Generic Environmental Impact Statement for License Renewal of Nuclear Plants

Supplement 14

**Regarding
R.E. Ginna Nuclear Power Plant**

Final Report

Figure 2-3. R.E. Ginna Nuclear Power Plant Layout

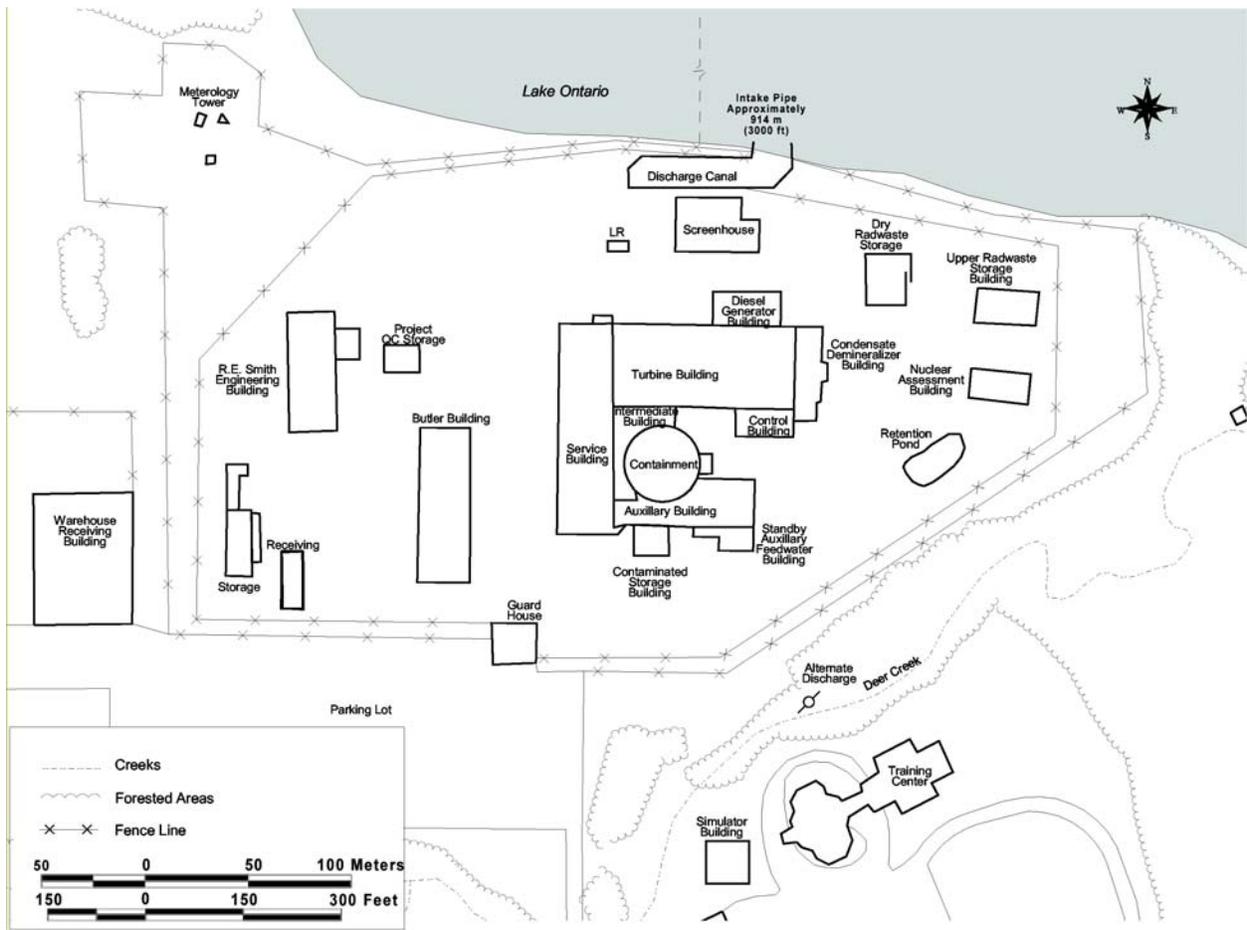
Comment: Minor changes should be made to Figure 2-3, as provided in Attachment B. (T-2)

Comment 1:	There is a typographical error on page 2-1, line 29. 0.9 km should be 2.4 km.	T-1
Comment 2:	Minor changes should be made to Figure 2-3, as provided in Attachment B.	T-2

Figure 2-4. R.E. Ginna Nuclear Power Plant Transmission Lines

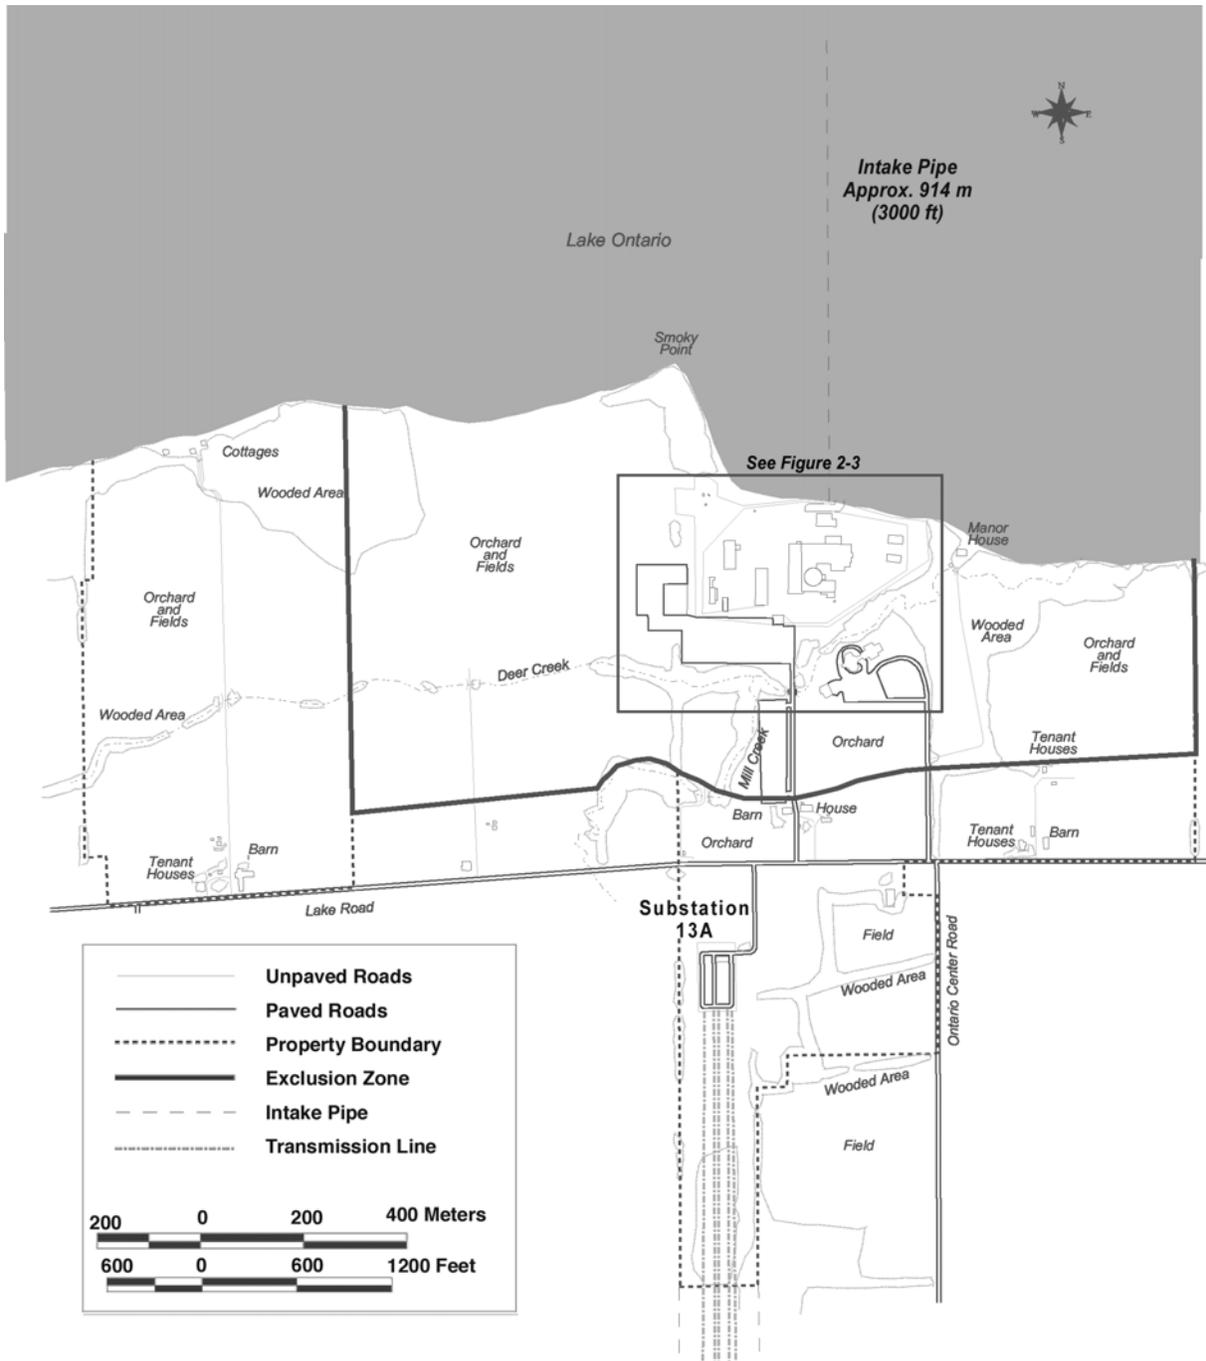
Comment: Minor changes should be made to Figure 2-4, as provided in Attachment C. (T-3)

Comment 3:	Minor changes should be made to Figure 2-4, as provided in Attachment C.	T-3
Comment 4:	In Section 2.2, page 2-17, line 25-27, reference is made to a land transaction. This has not occurred; therefore, this sentence should be deleted.	T-4
